UNITED STATES PATENT AND TRADEMARK OFFICE

| APPLICATION NO. | FILING DATE | FIRST NAMED INVENTOR | ATTORNEY DOCKET NO. | CONFIRMATION NO. |
|---|-------------|------------------------|---------------------|---------------------|
| 10/008,766 | 11/07/2001 | Robert H. Milmitch III | 50097-00003PT | 9188 |

DETAILED ACTION

A,B,C,D (Figure 1 reprinted below with annotations) in a four-post rack, with each emulate post defining a supporting point for a load (via the hole in flange 30; Figure 1).

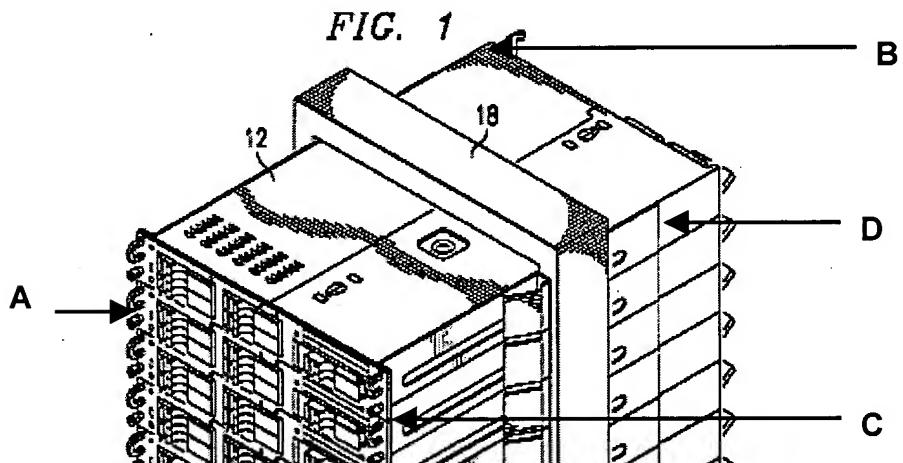
As to claim 52, Jensen et al. disclose a method for adapting a two-post equipment rack to support four-post loads, comprising:

coupling a first coupling member **20** to a first post **16**;
coupling a second coupling member **20** to a second post **16**;
coupling a third coupling member **20** to a first post **16** substantially planar to (the first and third coupling members lie within the same plane) and substantially parallel to a first coupling member **20**;

coupling a fourth coupling member 20 to a second post 16 substantially planar to (the second and fourth coupling members lie within the same plane) and substantially parallel to the second coupling member; and

Examiner disagrees. As to claim 52, Jensen et al. disclose a method comprising coupling a third coupling member **20** to a first post **16** substantially planar to (the first and third coupling members lie within the same plane) a first coupling member **20**; and coupling a fourth coupling member **20** to a second post **16** substantially planar to (the second and fourth coupling members lie within the same plane) the second coupling member (Figure 1).
